IMPORTANT ACTION RECOMMENDED HVE 3000 Flood Extractor All models

Date: September 3, 2015
To: HVE 3000 Flood Extractor Customers
RN#: 150903
RE: HVE 3000 Flood Extractor, all models

HEPA exhaust filter grill.

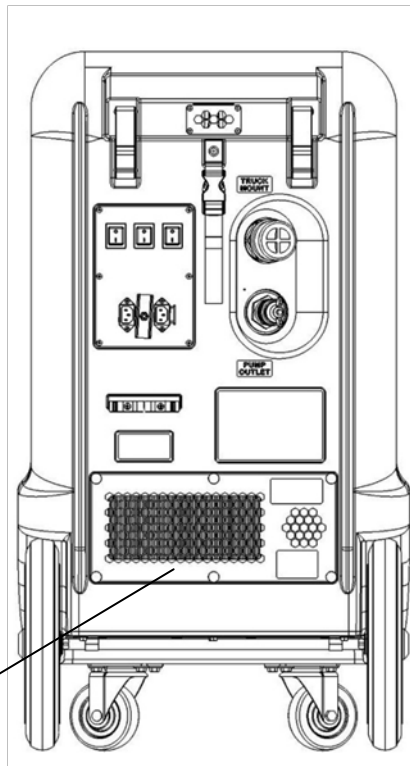
- Install the HEPA filter (*part no. F503, case of 4*) when using the HVE 3000 on Category 3 restoration jobs or where quieter operation is preferred. The filter is located behind the filter shroud – see illustration below
- Remove and discard filter at the end of the all Category 3 restoration jobs.
- On all other jobs, we recommend operating the unit without the HEPA filter in place. Hearing protection is recommended when the filter is not in place.
- Use defoaming chemicals whenever foam is present in waste tank.
- Replace the HEPA filter if it gets wet during operation.
- If foam/water is pulled through the vacuum blowers, remove hose/wand and run blower unit for 5 minutes to dry out the system prior to storing.

Thumbscrews allow easy filter replacement. To order replacements, ask for part no. F503 / 20-045, case of 4.
